## Determination 2020/007

### Regarding the compliance of sub-floor fixings to the foundations of a house at 43B Armagh Terrace, Marton

**Figure 2: Profile of the installed bearers**

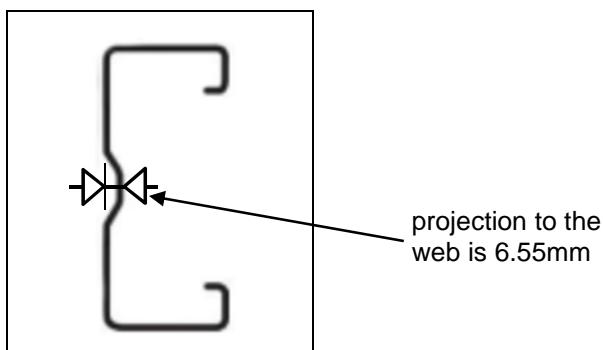
- 2.7 The web's inward projection at the mid-depth of the installed bearers has an impact on fixing plates and brackets fixed flat to the web as shown in:

- 2.8 The inwards projection of the installed section is 6.55mm, compared to 3.05mm for the section described in the building consent.

- the installed bearers are assumed to have the same dimensions as the consented bearers but have a different profile, which raises questions about the fixing details and the structural stability with regard to the profile of the bearer and its fixings

**Figure 3: Detail from the consent drawing (Dwg 406) showing the 125x50x8mm metal angle bracket supporting the SHS steel post above**

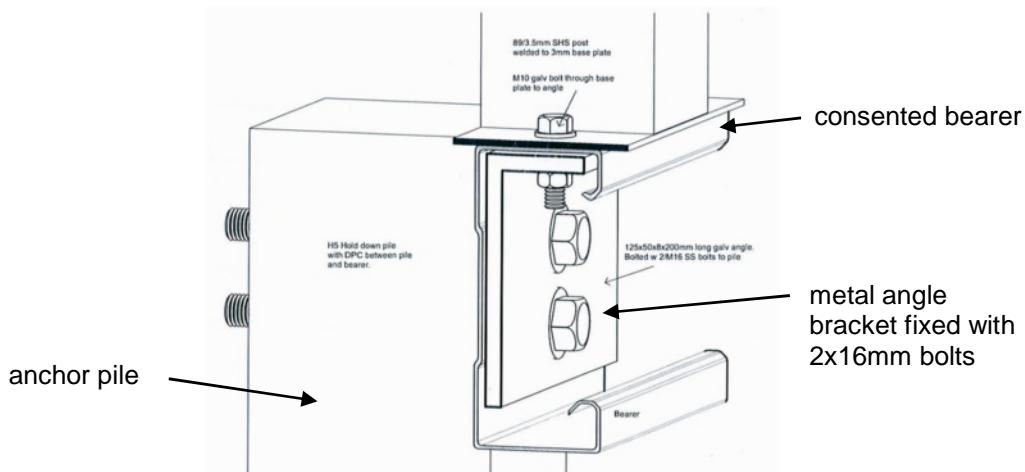
- the consented plan shows the SHS post is fixed directly onto the bearer via an 8mm thick bracket (refer Figure 3). As installed, the fixing plate is on an angle due to the profile of the bearer, and the bolt fixings are located between two piles.

- 5.2.6 The following is noted regarding the angle bracket's alignment and fixing:
- the bracket is not fixed flat or in close contact with the web of the bearer and the anchor pile, lacking proper alignment to either the bearer or the pile

- as a result of this misalignment the top of the bracket has rotated towards the anchor pile (around the central rib to the web) as shown in photograph 3 (refer paragraph 4.4, 2<sup>nd</sup> bullet) so the point load from the SHS post above is concentrated on the outside edge of the 50mm angle leg.

- 5.2.7 I have not been provided with evidence that sufficiently addresses the concerns raised by the authority regarding the misaligned bracket and whether the bracket can achieve the required design capacity with respect to uplift. Therefore, I am not satisfied the bracket is providing a compliant load path for the SHS post above.

**Figure 4: Detail from the consent drawing (Dwg 401) showing the splice plate fixing adjoining bearers to an anchor pile**

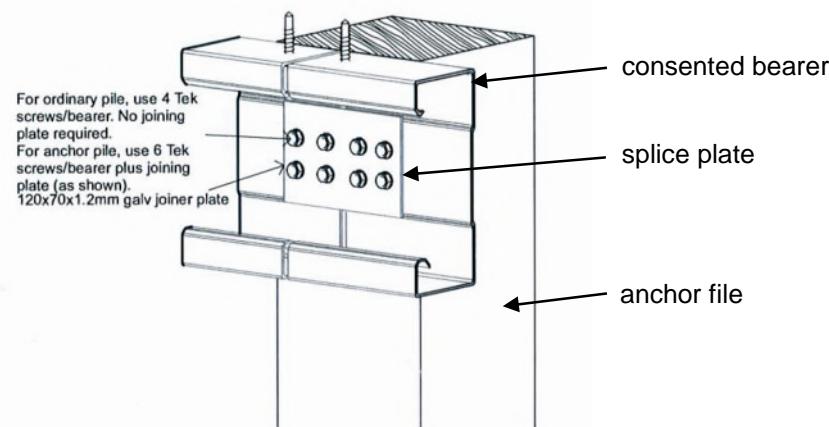
- the consented details show bearers join and connect to anchor piles via a fixing plate that bears against the flat mid-section of the bearer. This enables all components to be hard up against each other to provide the calculated connection strength to resist both horizontal and vertical forces

- because of the changed profile, the materials are not hard up to each other and as a consequence the connecting bolts/screws are not able to reach their full capacity. This is particularly significant for the fixing of the SHS post to the bearer and pile

- In fixing the splice plate to the installed bearer it has in effect been folded over the central rib to the web as shown in photograph 1 (refer paragraph 4.4, 1<sup>st</sup> bullet).
- The proprietary splice plate made for the installed bearer is designed to be fixed at the rear of the bearer as shown in Figure 5 (in this case between the bearer and the pile) so the fixings hold the bearer and splice plate in close contact. The proprietary splice plate for the installed bearer has not been used.

- The metal screw fixings are angled through the splice plate above and below the central rib leaving a gap between the splice plate and the web. The fixings do not hold the splice plate and the bearer in close contact with the timber piles. This gap will allow the joint to move before the fixings take up the intended load, leading to the joint's design capacity not being achieved.

- Excessive movement at these joints may result in a loss of amenity to the structure.
- 5.2.3 The splice plate as installed means the designed lateral capacity of these joints (between adjoining bearers and between the bearers and the anchor pile) is unlikely to be achieved. The foundation may have more anchor piles than might be necessary to achieve compliance and consequently these joints may not need to achieve full capacity for the structure to perform as intended, but I not been provided with any information from the applicant to verify this or to put forward such an argument.

- 5.2.4 Information about the basis of the design of the joints and the capacity that the joints are required to achieve has been requested but not provided. I consider insufficient information has been provided to demonstrate that the as-built splice plate detail is adequate, and that sufficient capacity can be achieved by these joints.
